## Memorandum

Winnetka Park District

Subject: Special Use Permit Review #1 – Centennial Park + Beach 255 Sheridan Road – (Case No. 24-08-SU) Review Responses (WPD)

V :  0' 10' 20'

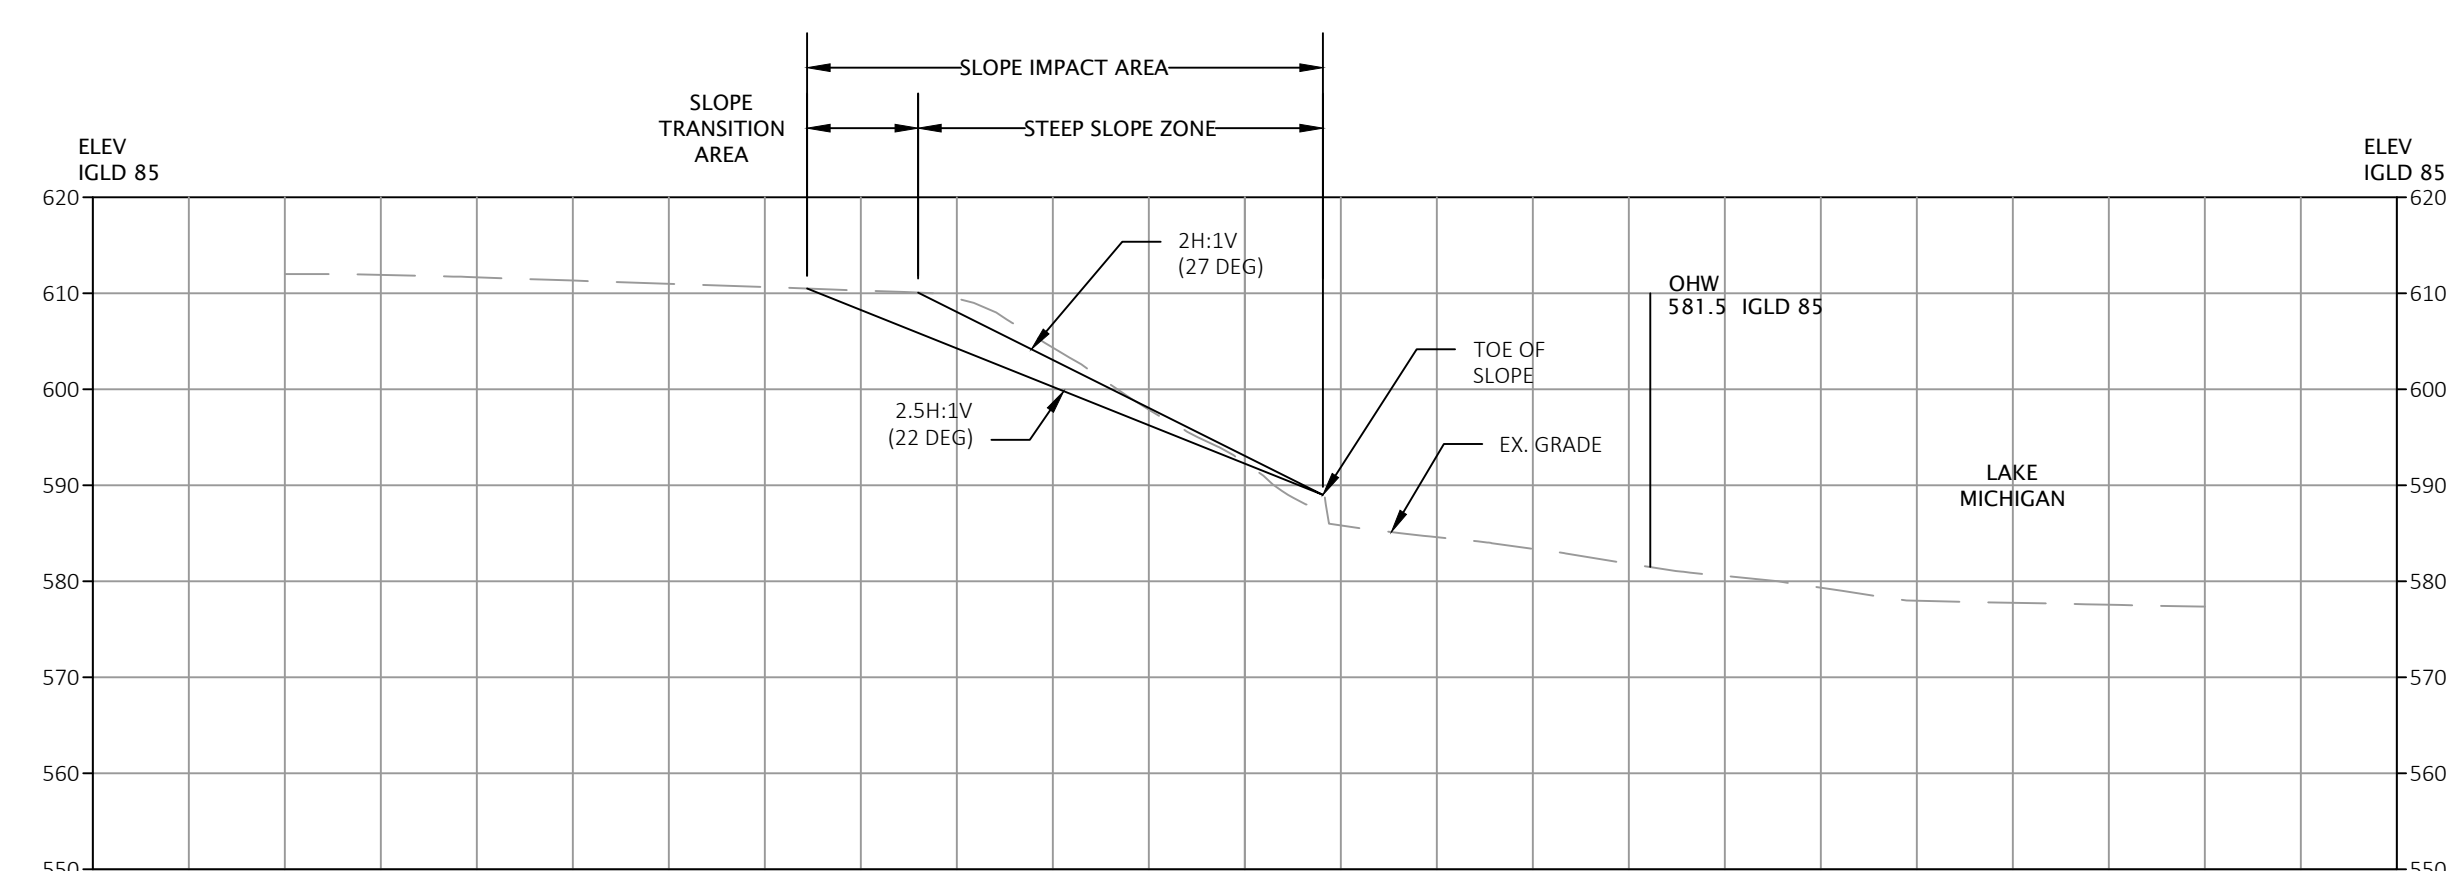
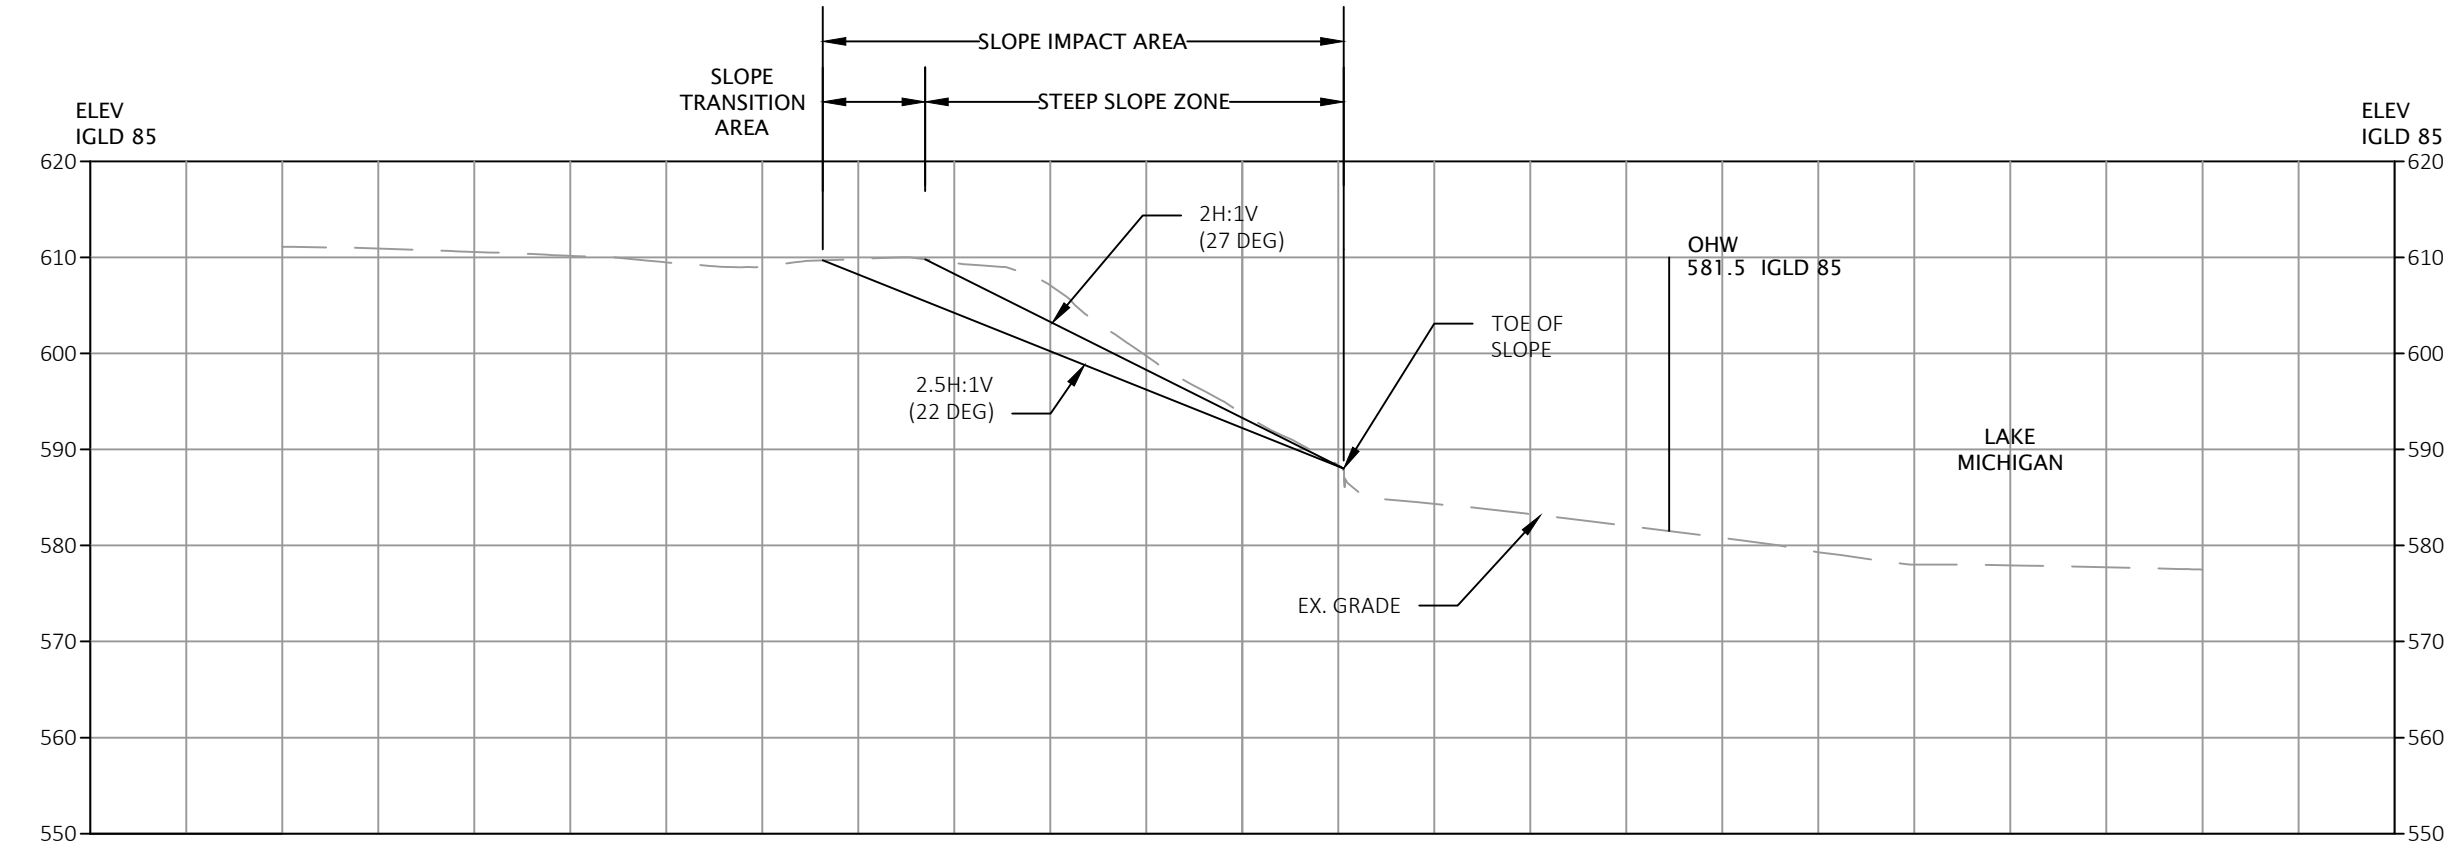
7. You must designate slope impact area, which includes the steep slope zone and slope transition area, on a topographic plan sheet, and provide the necessary cross sections to support these designations. Please see Engineering comments.

1. Per the recently adopted steep slope ordinance, a copy of which is attached, you must demarcate the location of the slope impact area, which includes the steep slope zone and the slope transition Page 4 area, in plan view and provide cross sections every 25 feet. If you have any questions, please reach out to the Engineering Department. Submittal must also provide information supporting how conceptually the design of the proposed plan within the slope impact area meets the Development Standards of Section 17.82.050.

**Response: The Plan Sheet and Cross Sections are noted in drawings CS-6 – CS-10.**

**Response: The Plan Sheet and Cross Sections are noted in drawings CS-6 – CS-10.**
